Subject: Aubrey Davis 30%

Subject: Cyclists suggestions for improving I-90 Trail Safety

On behalf of the cyclists who have been active participants in this trail safety project process and are supportive of most of the elements in the 30% design, we submit the following comments in response to the PRC's 30% design discussion of 7/7/2023.

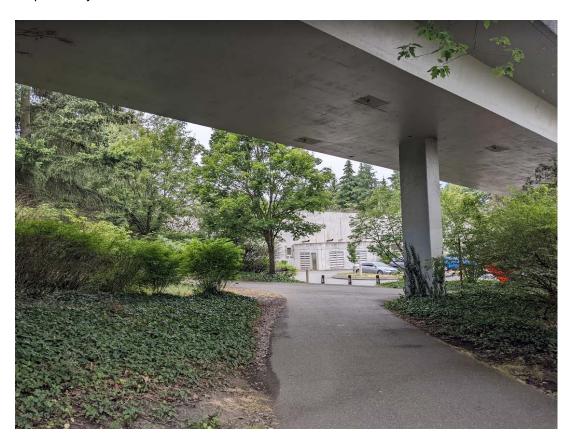
As I have mentioned in the past, this is a very dark location and I hope this helps to illustrate why luminaires will be required for any design that imposes an obstacle to bicycle traffic.

The location sits directly North of a retaining wall and directly underneath the 72nd Ave. Further, it is surrounded by trees and there is no existing lighting in the vicinity.

In short, it's dim in the day and a black hole at night.

Please consider all of the impacts to Safety that a roundabout with any obstacles imposes on bicycle traffic.
